# gDC Consensus Discussion

# Recap of last time... (draft 1.1)

# TP1a Values

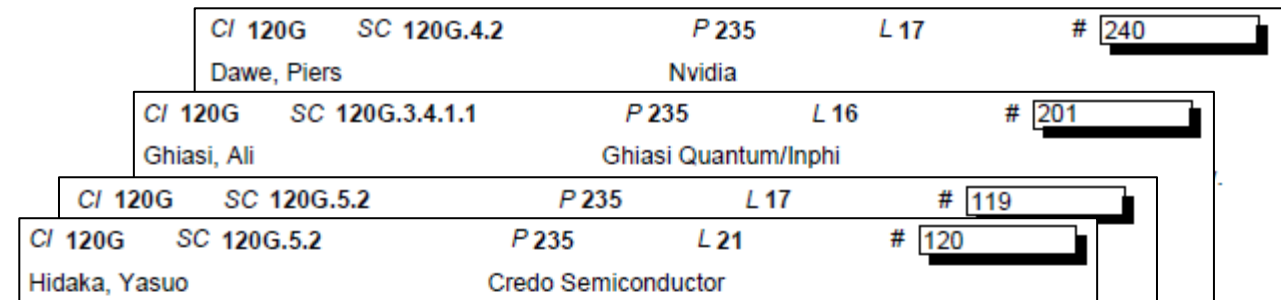
CI 120G SC 120G.5.2 P 235 L 10 # 225

CI 120G SC 120G.5.2 P 235 L 7 # 117

CI 120G SC 120G.5.2 P 235 L 7 # 118

gDC					Regardless of frequency
gDC2	D1.2	Dudek (#225) & Hidaka (#117)	Hidaka (#118)	D1.1	
0	-2 to -9	-3 to -9			
-1, [-0.5]	-2 to -12	-3 to -12			
-2, [-1.5]	-4 to -12	-4 to -12	-3 to -13	-3 to -14	
-3, [-2.5]	-6 to -13	-8 to -13			
gDC2 count	7	7	7	4	
	8+22+18+16 = 64	8+22+18+12 = 60	11*7 = 77	12*4 = 48

Proposed accept the values modifications on previous slide, leave dependence of gDC and gDC2.

# TP4 Far-End

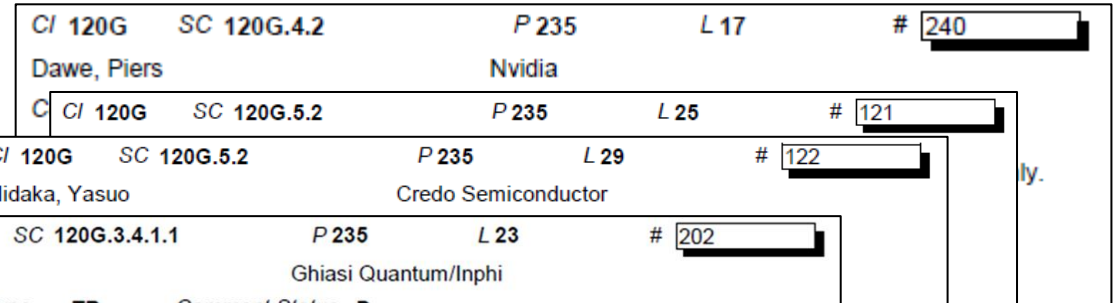
gDC2	D1.2 gDC	Hidaka (#121/122)	Ghiasi (#202)	Dawe (#240)	Compromise??
0	TBD		-2 to -9	-2 to -4	
-1, [-0.5]	TBD		[0.5] -2 to -9 [1] -2 to -10	-2 to -7	
-2, [-1.5]	TBD	-3 to -9	-4 to -10	-4 to -10	
-3, [-2.5]	TBD		-8 to -10	-8 to -10	
gDC2 count	7	4	7	7	
Test count	8+22+18+16 = 64	7*4 = 28	8+8+9+14+6 = 45	3+12+14+6 = 35

Is there a compromise here??
